Updates on Technical Review Comments

AEM's FEIS Addendum for the Meliadine Extension Project Proposal

March 15, 2023

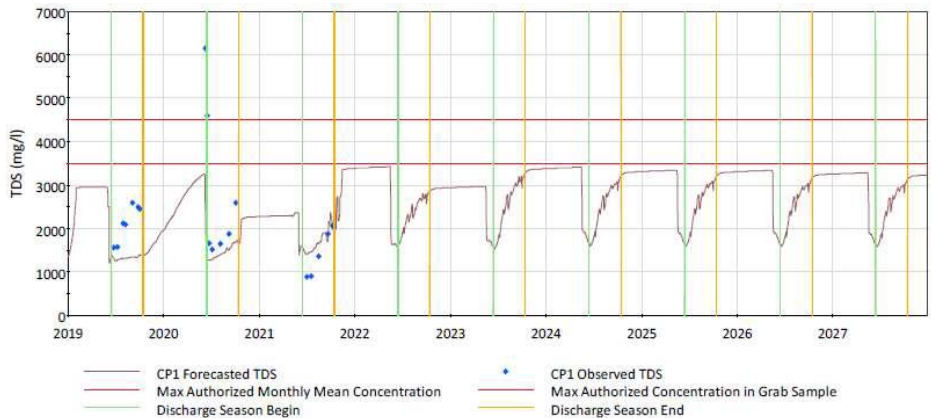
Importance of Issue to Impact Assessment	The FEIS Addendum for the Meliadine Extension indicates that discharges to Meliadine Lake will be significantly greater than previously predicted. Further information on the causes of these increases is necessary to understand the potential incremental impacts associated with the Meliadine Extension.
Detailed Review Comment	<p>During the NIRB review of AEM's proposal for the "Saline Effluent Discharge to the Marine Environment", AEM developed an Adaptive Management Plan (AMP) for Water Management. The AMP was submitted as Appendix D-01 to the FEIS Addendum for the Meliadine Extension. The first guiding principle of the AMP is as follows:</p> <p><i>1. Water discharges to Meliadine Lake will be minimized or eliminated (per commitment made during the waterline application and reflected in Term and Condition 25a, per Project Certificate No.006 – Amendment 002).</i></p> <p>At the time of the Waterline EA, AEM indicated that discharges to Meliadine Lake would be significantly lower than had been predicted during the original approval of the Meliadine Mine (per the 2014 FEIS). Specifically, the Waterline EA indicated that the maximum volume of water requiring discharge to Meliadine Lake would be 4,034 m³/day if the waterline was approved (see AEM response to CIRNAC TRC-05 from the Waterline Review process). Assuming water is also discharged via the waterline at a maximum rate of 20,000 m³/day, discharges to Meliadine Lake were therefore predicted to represent only 17% of all discharges (with the remaining 83% being discharged to Itivia Harbour).</p> <p>In contrast, the FEIS Addendum for the Meliadine Extension Project (Appendix H-07 S.5.1.4) states:</p>

Review Comment #	CIRNAC-TRC #4
	<p><i>The maximum predicted annual discharge volume to Meliadine Lake translates to a daily maximum discharge rate of 17,200 m³/day assuming that the EWTP discharges continuously over the full discharge window of 151 days between June 2 and October 30.</i></p> <p>Under this scenario, discharges to Meliadine Lake would be more than 300% greater than predicted at the time of the Waterline EA. In addition, the proportion of discharges to Meliadine Lake would also increase to 46% (with the remaining 54% being discharged to Itivia Harbour).</p> <p>Based on our review of the FEIS Addendum for the Proposed Project, CIRNAC is unable to identify the rationale for the substantive increases in the volume of discharges to Meliadine Lake relative to the volumes that were predicted at the time the Waterline EA was approved. In addition, CIRNAC has not identified information to confirm that discharges to Meliadine Lake will be minimized under the Meliadine Extension proposal. To address these information gaps, CIRNAC-IR-6 requested that AEM:</p> <ul style="list-style-type: none"> a) Confirm the maximum discharge volumes to Meliadine Lake, as presented in the Waterline FEIS and the Meliadine Extension FEIS; b) Present the rationale for any differences in the volumes reported under a); and c) Indicate what steps will be taken to fulfill the commitment to minimize or eliminate discharges to Meliadine Lake (e.g., ongoing grouting to limit saline water inflows to the mine). <p>AEM's response to CIRNAC-IR-6 provided limited additional information to address the requests noted above. For instance, in the case of item a), AEM cited the maximum discharge volumes associated with the 2014 FEIS, not the Waterline FEIS. Regarding item b), AEM's stated rationale is insufficient to explain the more than 300% increase in discharges to Meliadine Lake under the Meliadine Expansion FEIS relative to the Waterline FEIS. Finally, for item c), given the predicted 300% increase in discharges to Meliadine Lake under the Meliadine Extension FEIS relative to the Waterline FEIS, CIRNAC does not support AEM's position that discussions regarding the steps AEM will take to fulfill their commitment to minimize discharges to Meliadine Lake should be deferred to the Type A Water Licence Amendment process with the NWB.</p>

Recommendation / Request	<p>CIRNAC recommends that AEM¹:</p> <ul style="list-style-type: none"> a) Confirm the maximum discharge volumes to Meliadine Lake, as presented in the Waterline FEIS and the Meliadine Extension FEIS; b) Present the rationale for any differences in the volumes reported under a); and c) Indicate what steps will be taken to fulfill the commitment to minimize or eliminate discharges to Meliadine Lake (e.g., ongoing grouting to limit saline water inflows to the mine).
Updates on March 15, 2023	<p>From technical point of view CIRNAC has concluded that this issue is classified as resolved as the volumetric discharges to Meliadine Lake under the extension are less than those that were assessed under the 2014 FEIS. As such, it is CIRNAC's opinion that the activity was already approved under the existing project certificate.</p>
